From: [Bernard Greene](#)
To: [Communications](#)
Cc: [SIDS](#); [Kate Bradley](#); [Liam Flynn](#)
Subject: ACP-324290-26 Lissinagroagh Wind Farm SID / RED III application
Date: Tuesday 21 July 2026 15:45:06
Attachments: [Cover Letter Lissinagroagh Wind Farm 21.07.2026.pdf](#)
[CE Report - Lissinagroagh Wind Farm SID - Final - ACP.pdf](#)
[Microsoft PowerPoint - Lissinagroagh Wind Farm SID RED III 20.07.2026.pdf](#)
[Meetings Administrator Record of Special Meeting 20th July 2026.pdf](#)

Reference: ACP-324290-26
Leitrim County Council Report – Proposed ‘Lissinagroagh Wind Farm Development’ (Application for Strategic Infrastructure Development under Section 37E of the Planning and Development Act 2000 (as amended)).

Comhairle Chontae Liatroma Leitrim County Council	Leitrim County Council Planning Report
Planning Reference No:	PAX12.324290 / ACP-324290-26
Applicant:	FuturEnergy Lissinagroagh Designated Activity Company (DAC)
Location:	Located in the townlands of Boleyboy, Cashelaveela, Cherrybrook, Killea, Coolodonnell, Faughary, Lissinagroagh, Lisdarush, Lugasnaghta, Raheelin, Shasmore, Tawnyfeacle and Tullyskeherny, Co. Leitrim
Application Type:	Strategic Infrastructure Developm

Figure 10: Road Network and Proposed Sites Entrances (Source: Figure 16.4 of EIAR)

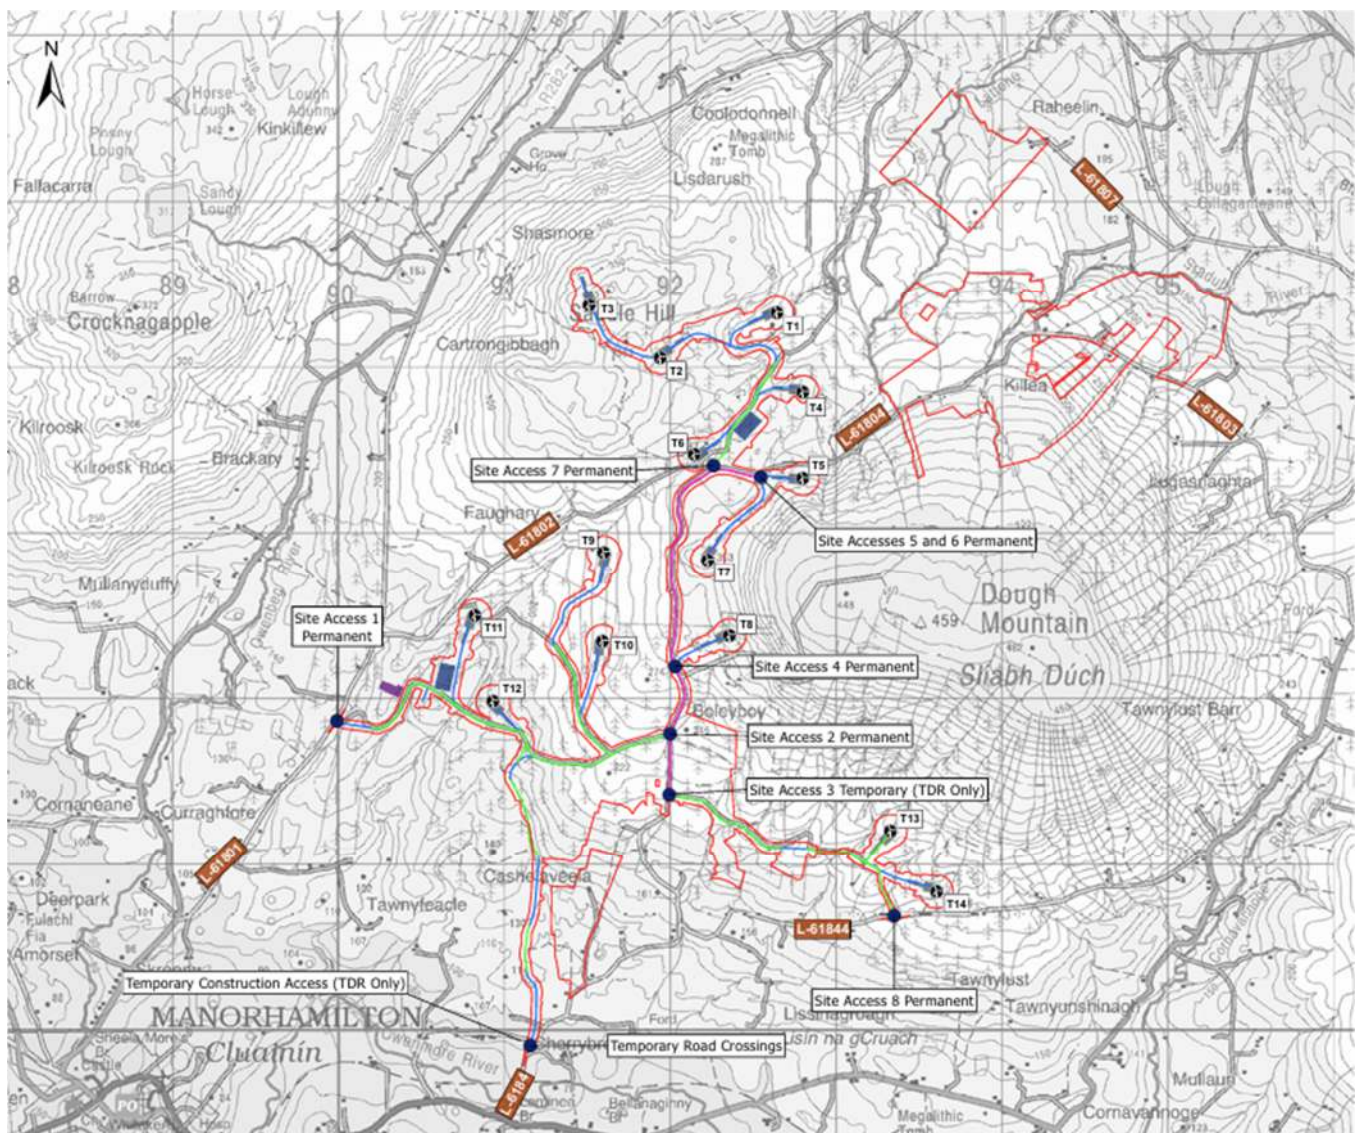
- Permanent Site Entrance 7 (Faughary Td.) is north of the junction of the L6184, L61802 and L61803. It will use an existing access for construction and operation to serve turbines 1, 2, 3, 4 & 6. This is not off the L6184 as stated in Section 16.4.1 Accesses but not considered significant.

At Cherrybrook, located to the south of the proposed project, the proposal will include a temporary site access 1 for use during the construction phase. This is located opposite the entrance to Brookfield House. A new temporary road is proposed for construction purposes which will traverse the L6184 (referred to in the EIAR as an 'unnamed road') and then cross agricultural lands before connecting with existing internal forestry roads within the Coillte landholding. These crossings are designed to facilitate turbine component deliveries by avoiding a tight bend on the existing road and eliminating difficult turning manoeuvres, thereby minimising the extent of use of the public road network. Temporary Site Access 2 (Lissinagroagh Td.) will consist of a modified existing temporary entrance onto the L6184 to be used during construction and is referred to above in connection with Permanent Site Access 3.

Figure 15: Extract from Site Layout Plan Sheet 9 of 9

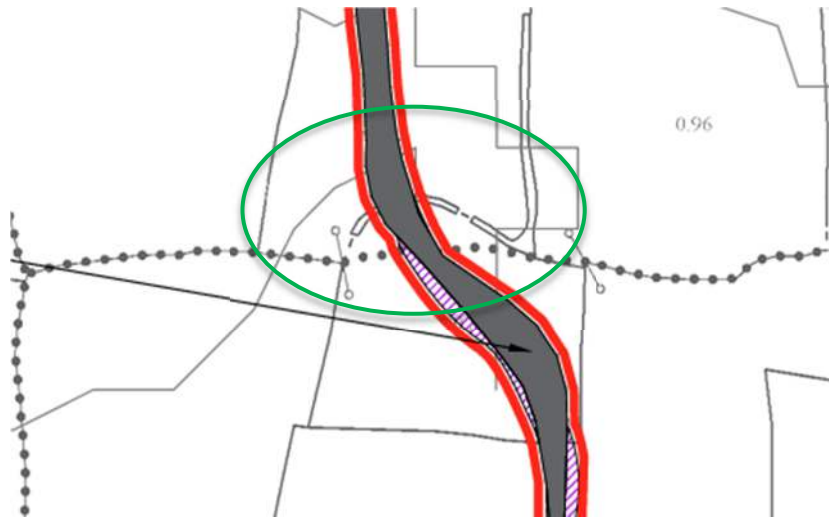
The proposed access road from Cherrybrook to connect with existing forest access tracks is stated in the EIAR to be 860 metres in length. It traverses across a local road which the EIAR states is not named. It is a named roadway as outlined earlier in this report. The Site Layout Plan (Sheet 9 of 9) has 2 no. annotations shown with respect to this access road, 'Proposed Temporary Site Access 1 (Refer to Drg. No: 10955-2078 for details, Turbine delivery only)' and 'Proposed Site Access Road (Refer to Drg. No: 10955-2033 for details)'. The drawing also shows that the entirety of this track is shown in dark grey which from the legend corresponds with '*Proposed Permanent Access Road*' although considered an oversight. The former drawing referenced in the annotations is a generic drawing titled 'Proposed Track Construction Details'. It refers to 3 types of Access Track – Excavate & Replace; Standard Access Road Construction; and Widening of Existing Track (outside of peat areas). It is assumed that the subject roadway is Type 2 although an EIAR should not rely on a consenting authority having to make assumptions. The latter drawing is not a standard road design drawing and shows minimal detail on an aerial overview. There is no legend shown on this drawing. No details of the road construction, width, finished ground levels, treatment with existing public roads, etc. are provided. No contours are provided to allow the Planning Authority to present an informed view to the Commission. The access roadway does appear from examination of mapping that it traverses across a drain with no details of proposed culverting. This is shown in the green oval overleaf in Figure 15.

The details submitted in this regard are sub standard and do not allow an informed opinion of the impact of such a roadway on the landscape to be formed notwithstanding it's temporary impact or the traffic safety impacts for both local roads affected by this proposal. The details have not demonstrated the achievement of the requisite sight distances for vehicles exiting onto the L6184 local roadway. If this is only used for turbine delivery, it will be presumed that there will be temporary traffic management measures in place for access and

egress which would be closed off for all other purposes. The only drawing that shows any contours for this access roadway is within the Swept Path Analysis (Location 03 - L6184 Site Entrance). This does not conform to the guidance provided for Wind Energy developments in that *“Access roads/tracks should relate to key characteristics of landscape, e.g., the roads should not follow a straight line up a Mountain Moorland slope directly to the wind energy development, but rather a diagonal line following the contours.”*

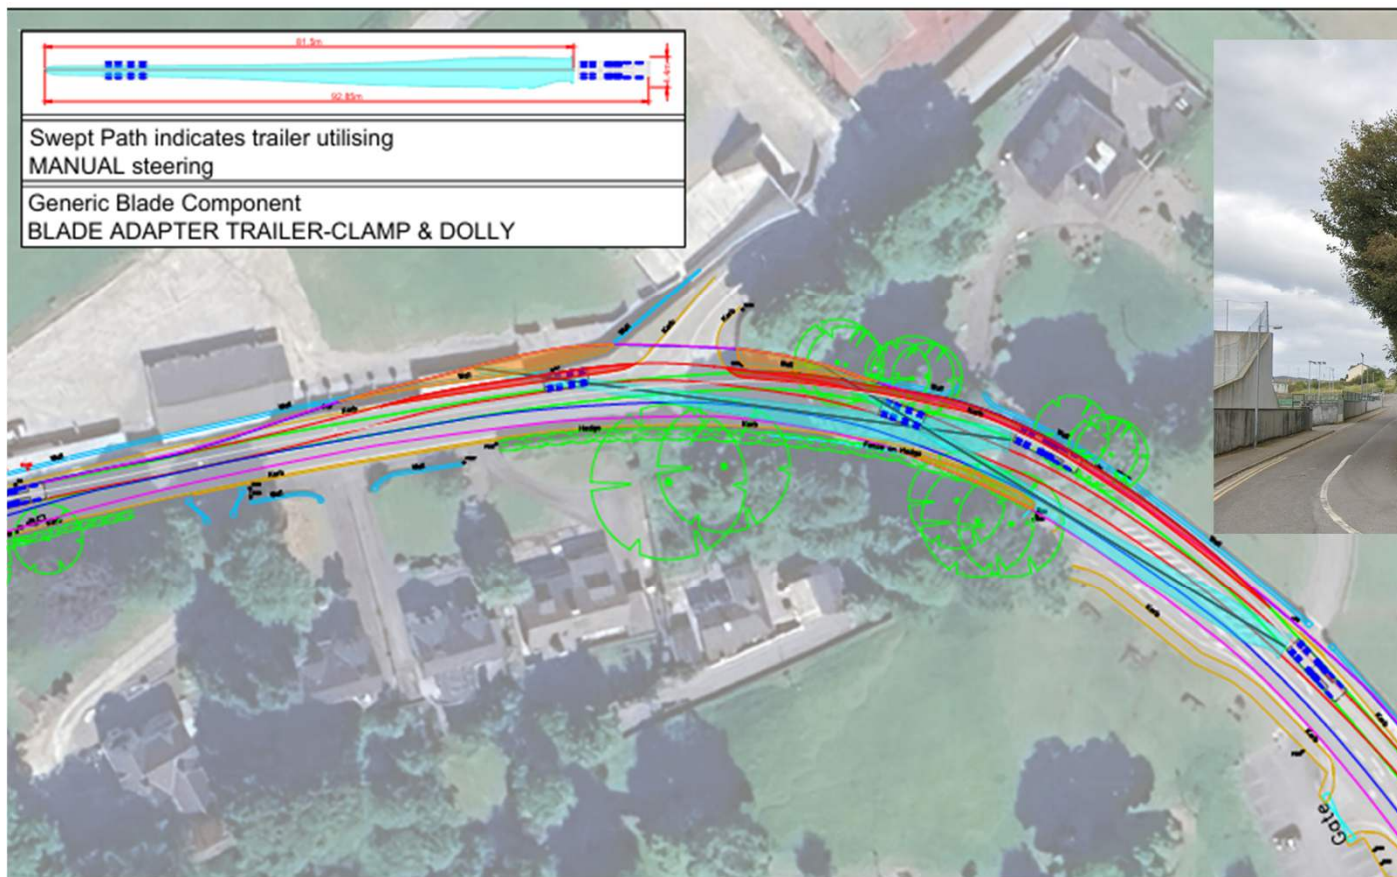
6. Legal Considerations

The Planning Authority would have expected that an application of this nature would have been accompanied by a map which would clearly outline the ownership of all of the lands included in the red line boundary of the proposed development and the blue line boundary of the submitted overall landholding included in the application for consent. What has been submitted is a series of letters which outlines land folios and the consent of the various landowners to the making of the application to An Coimisiún Pleanála. It is something which the Commission should give some thought to in their pre application consultations with perspective applicants. Again, without sight of the completeness assessment undertaken by the Commission, it is unclear if this matter was considered.

7. Consideration of Alternatives
